SUBJECT: Forwards comments on VRC review of operating experience  
 "Non-DBE Reductions in Coolant Inventory (Leaks)" suggested  
 as more appropriate categorization of steam generator tube  
 leaks.

Subject: Review of Operating Experience  
R. E. Ginna Nuclear Power Plant  
Docket No. 50-244

Attachment 1  
Comments on NRC Report:  
Ginna Operating Experience

**Fig. 1 - Cross-Sectional View of Type DB-50 Circuit Breaker**

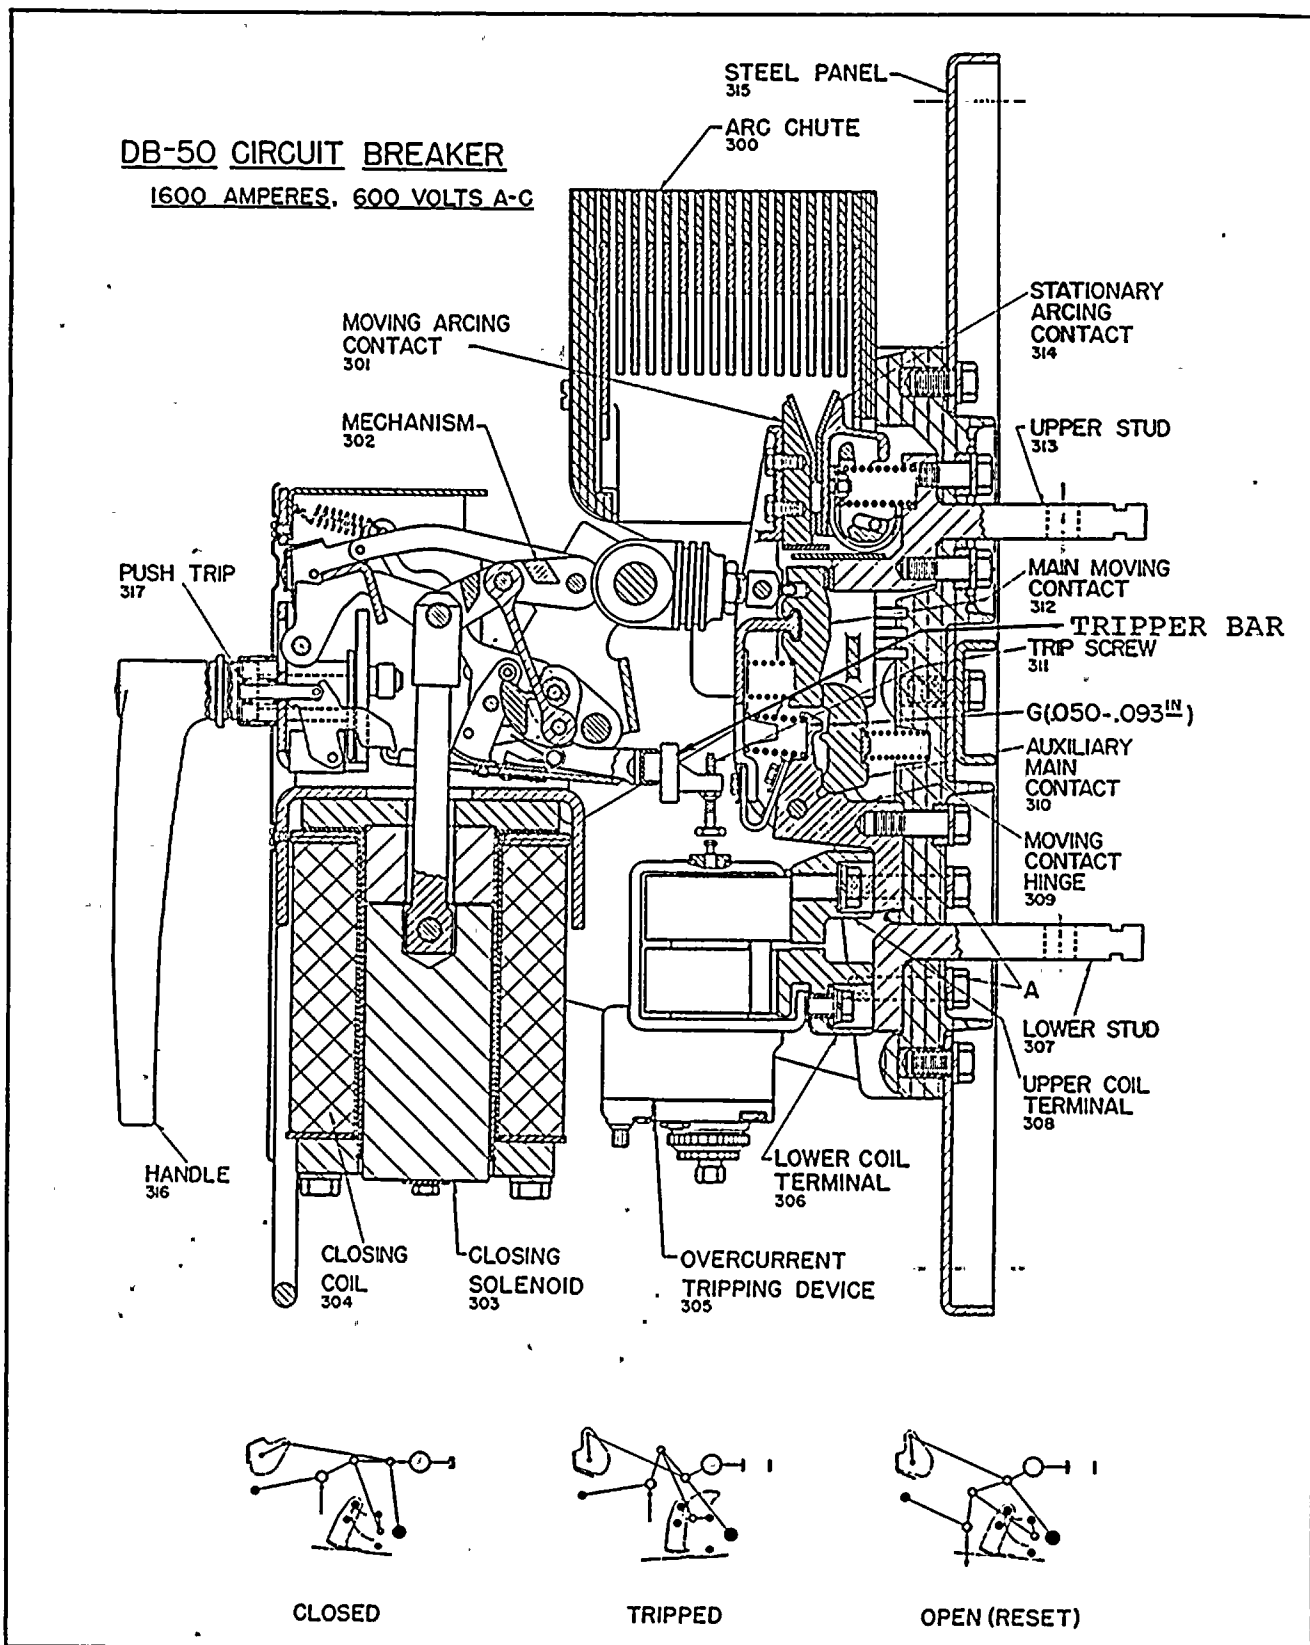
In order to confirm the findings of preliminary analyses and tests performed at the site, Breaker SIP1C1 was sent to the East Pittsburgh Plant of Westinghouse for diagnostic testing. The result of these tests are described below.

Fig. 2 - Electric Lockout Attachment - Construction Details

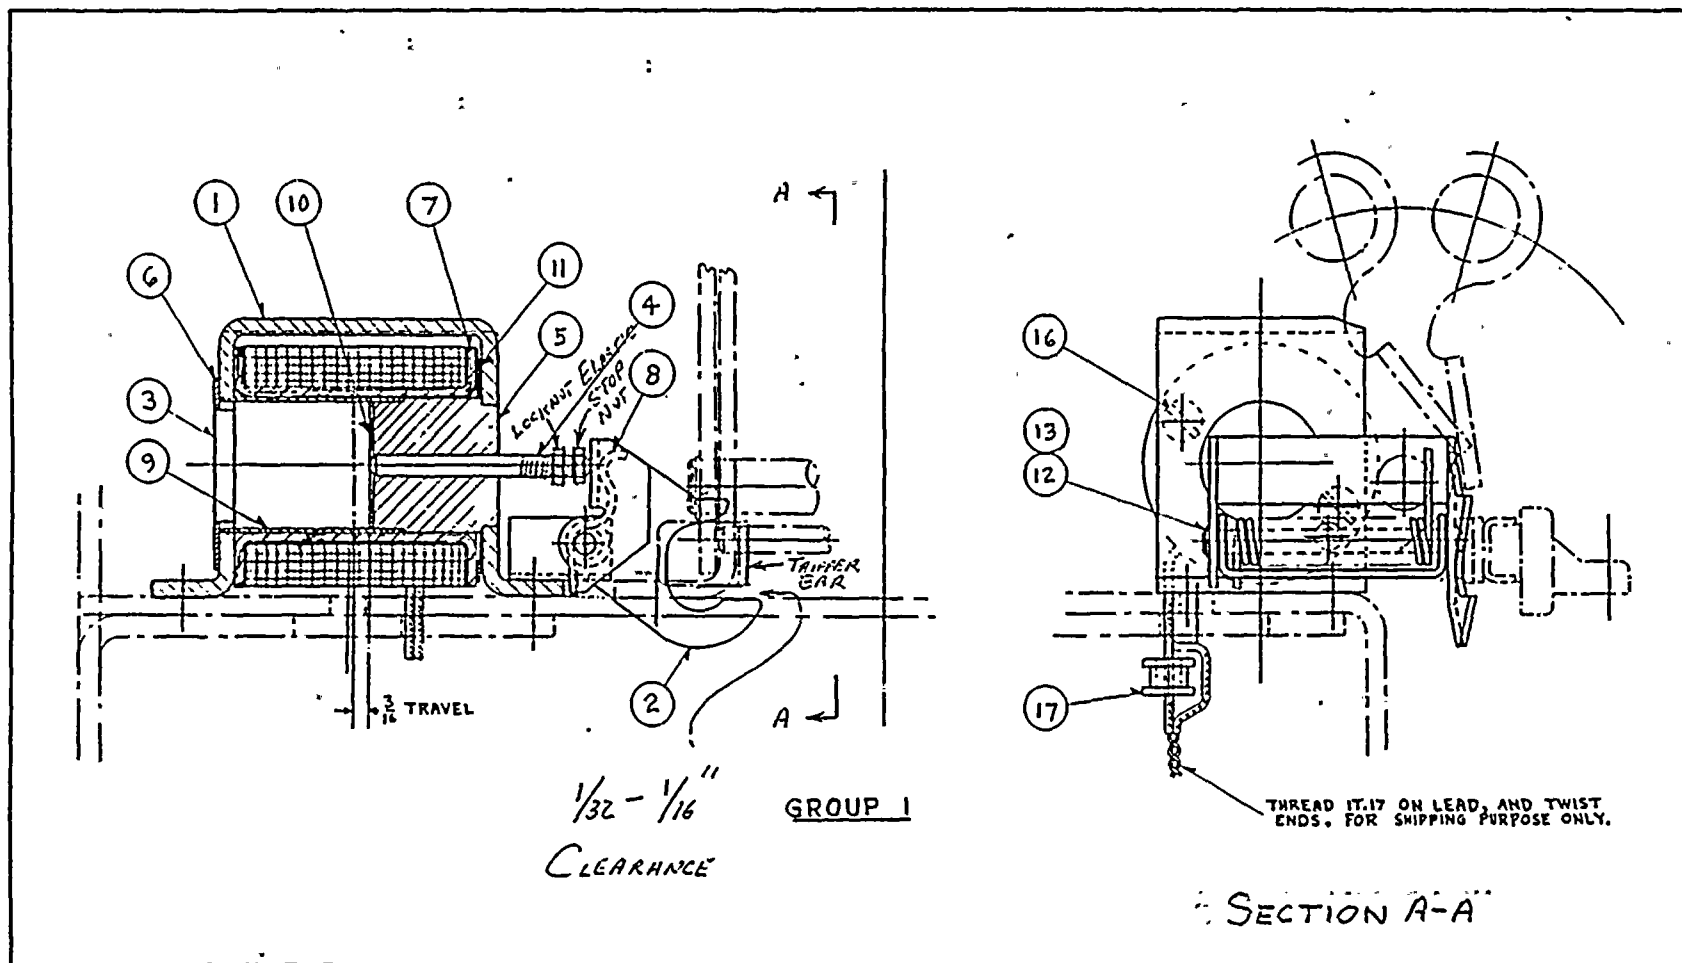
The failure of Circuit Breaker SIP1C1 to close upon receipt of a close signal was determined to be due to inadequate clearance between the lockout assembly and the "tripper bar" which prevented the tripper bar from locking into the closed position, and therefore simulated an overcurrent condition in the breaker. It should be noted that the principal function of the tripper bar is to open the breaker when the overcurrent coil internal to the DB-50 breaker actuates (See figure 1). Existing instruction books for the "DB" breakers with the lockout attachment state there are no adjustments for this clearance, however, Westinghouse has since developed an adjustment method. By loosening the locknut, the elastic stop nut can be turned to adjust the clearance between the lockout assembly and the tripper bar. The clearance should be 1/32"-1/16" with the lockout coil in the energized position (See figure 2).

It is recommended that plant maintenance procedures be modified to check, and adjust if needed, clearance of the lockout assembly on "DB" breakers that have this lockout feature in accordance with the W procedure. This is in addition to any existing maintenance procedures that may apply. When maintenance procedures have been modified, reliability and availability of the breakers will be acceptable.
